HIGHLAND COUNCIL

Committee: North Planning Applications Committee
Date: 17th September 2024
Report Title: 23/02702/MSC: Compass Building And Construction Services Ltd
Land 255M East Of Culcairn Farmhouse, Station Road, Evanton
Report By: Area Planning Manager - North

Description: MSC application for phase 1 private housing to satisfy matters specified in conditions 1, 2 and 4-25
Ward: 06 – Cromarty Firth
Development category: Major Housing Development
Reason referred to Committee: Manager's Discretion

Drawing No.	Revision
3789:101/01	E

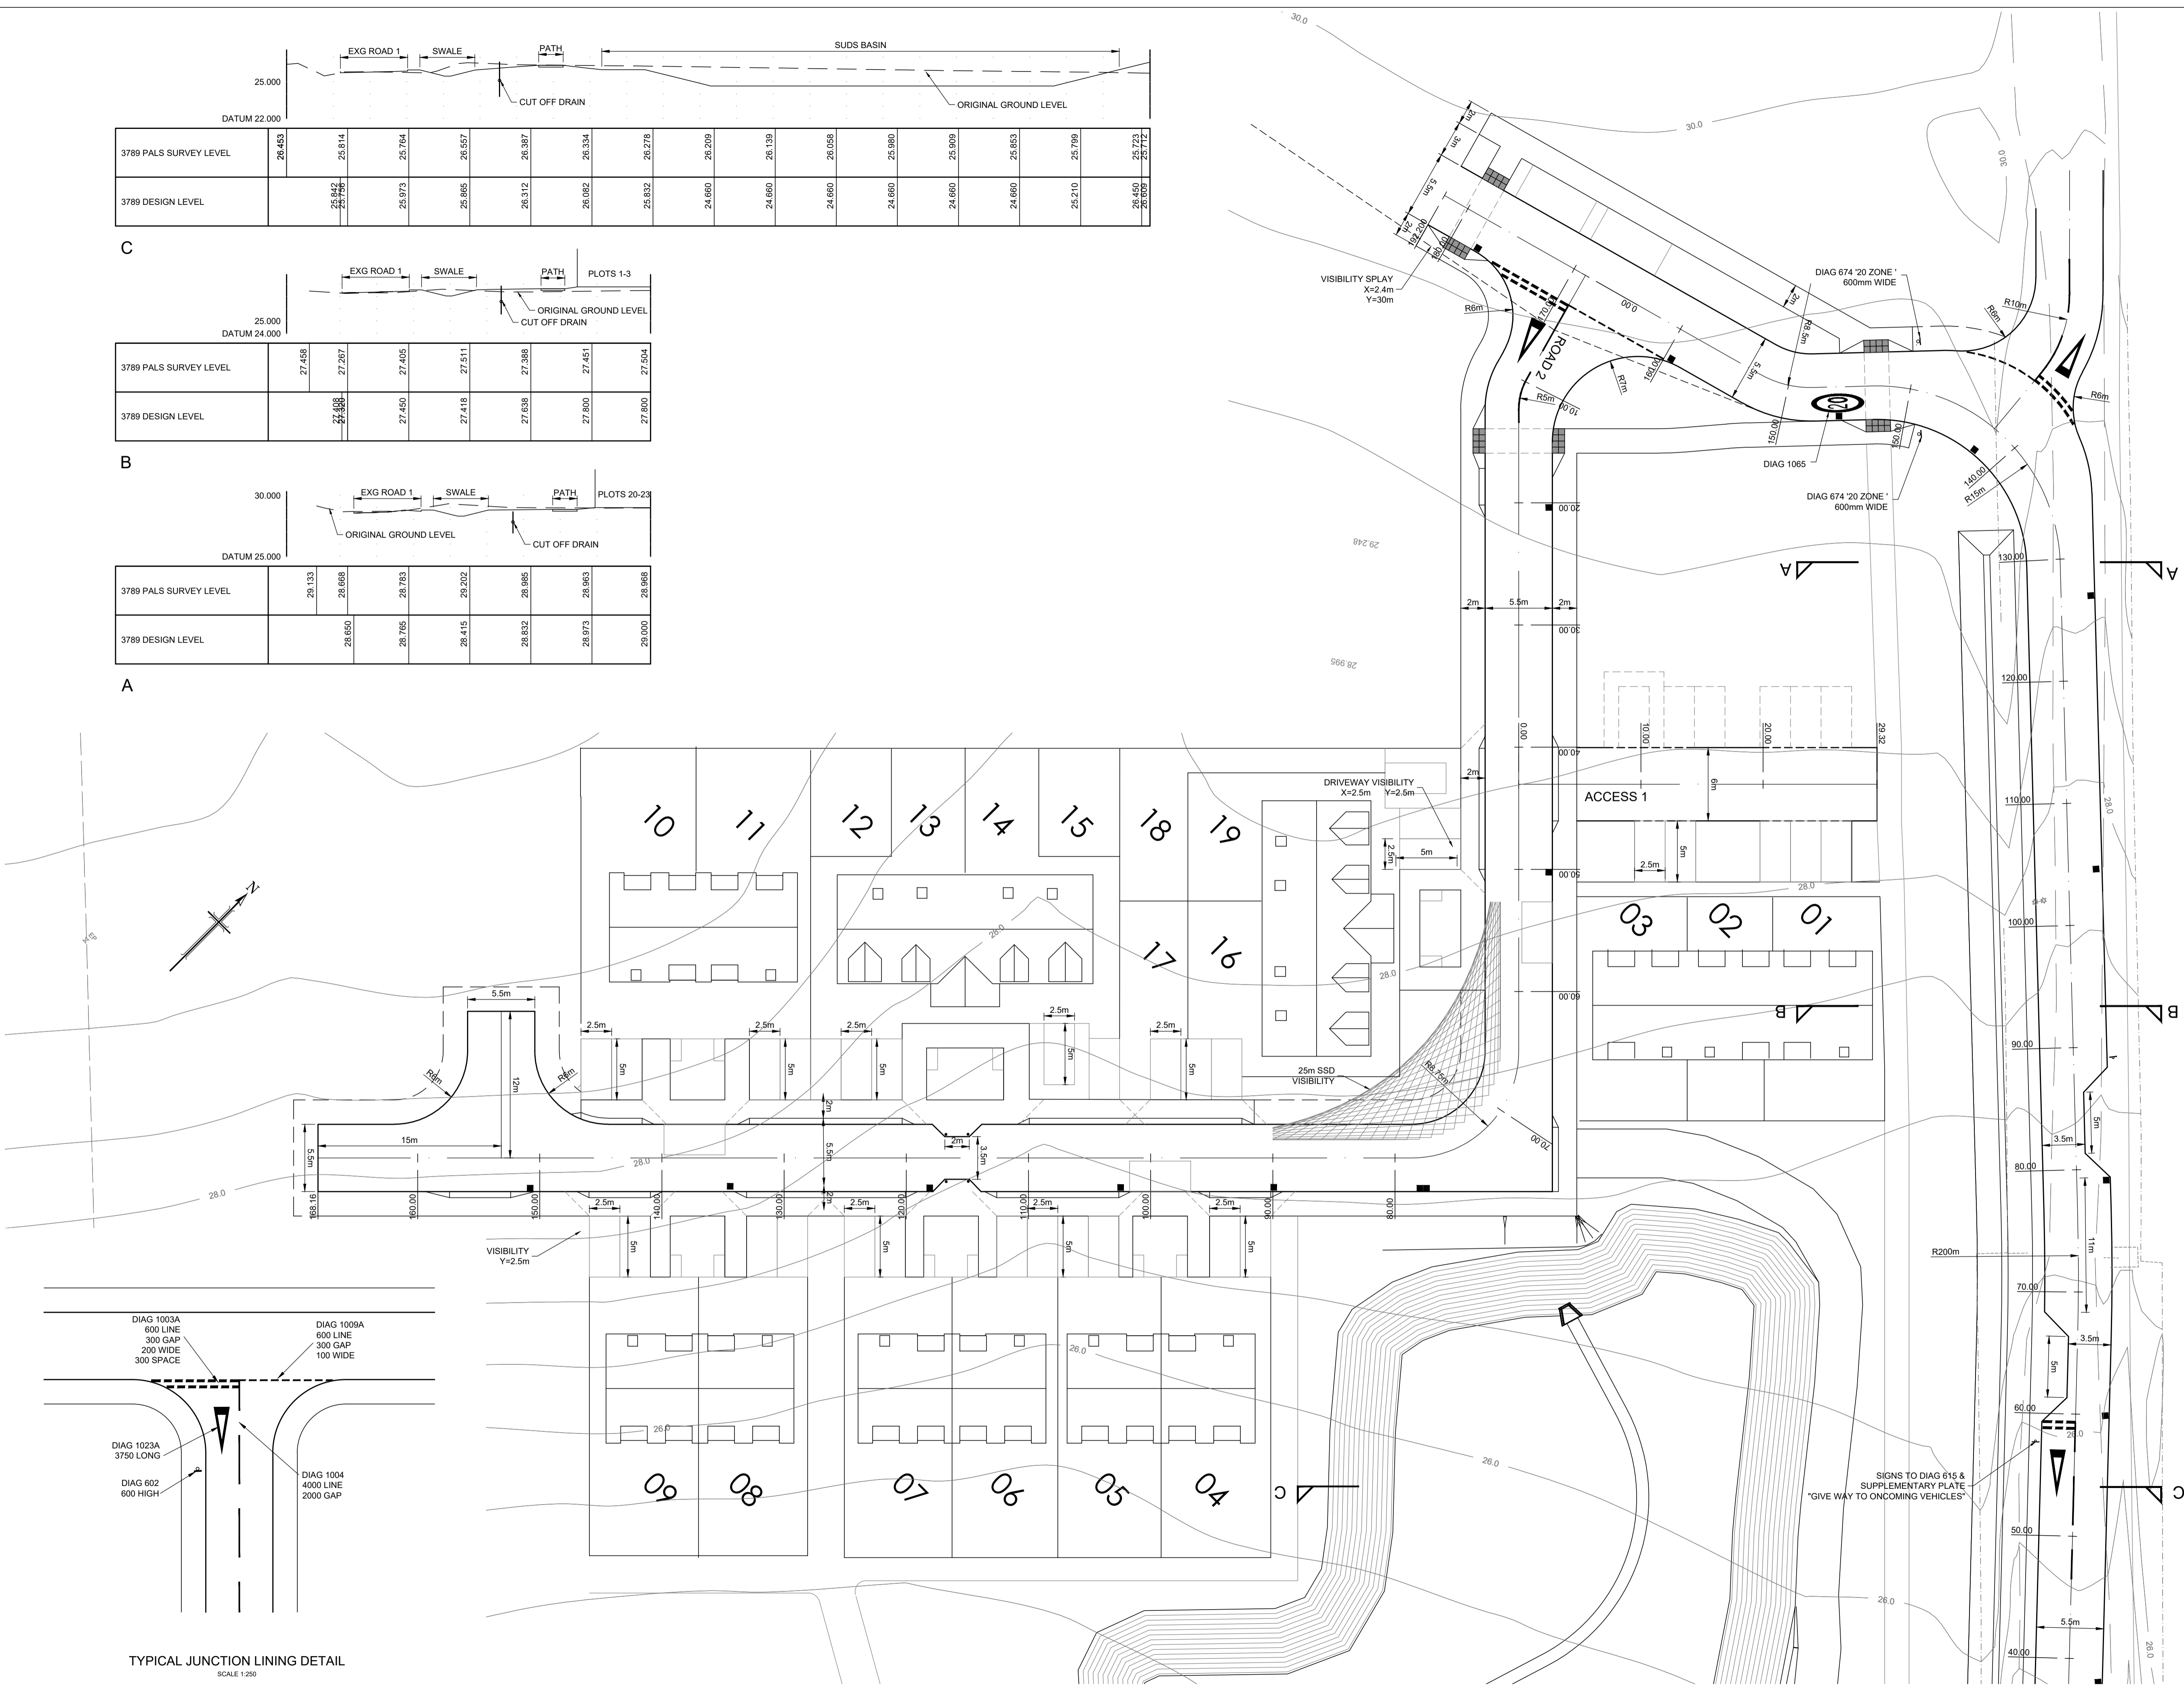
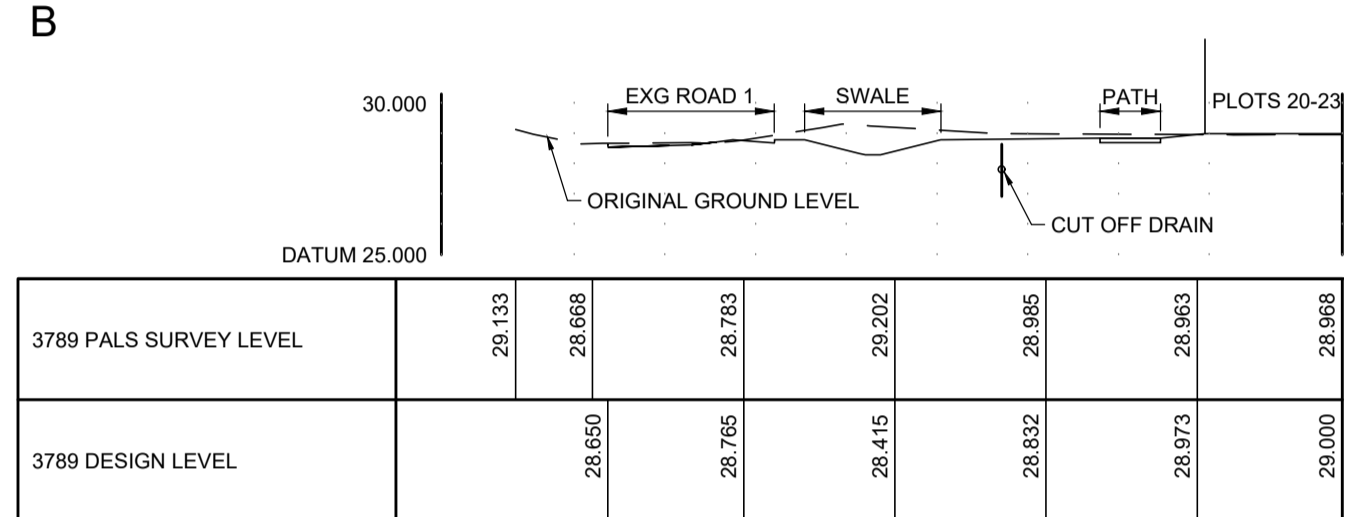
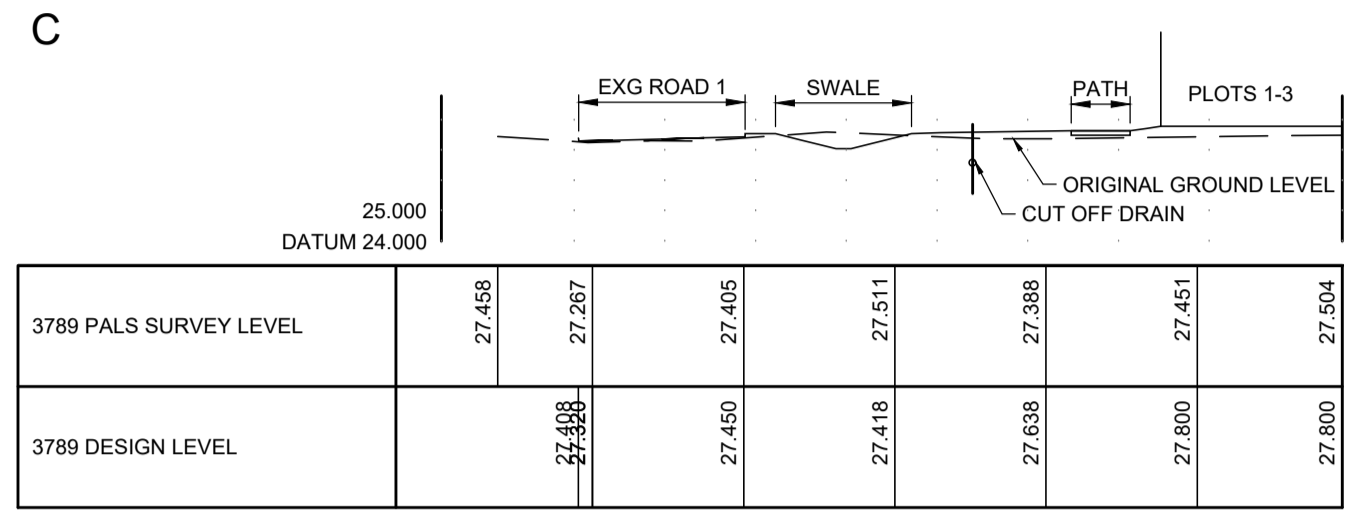
- 8.48 **Condition 21** - Any details pursuant to Condition 1 above shall include provision and maintenance in perpetuity of visibility splays of 4.5 x 120m to the north and 4.5 x 90m to the south from the main vehicular access from the site onto the B817. Transport Planning confirm that Drawing 3789:101/02 Rev E shows the required splays.
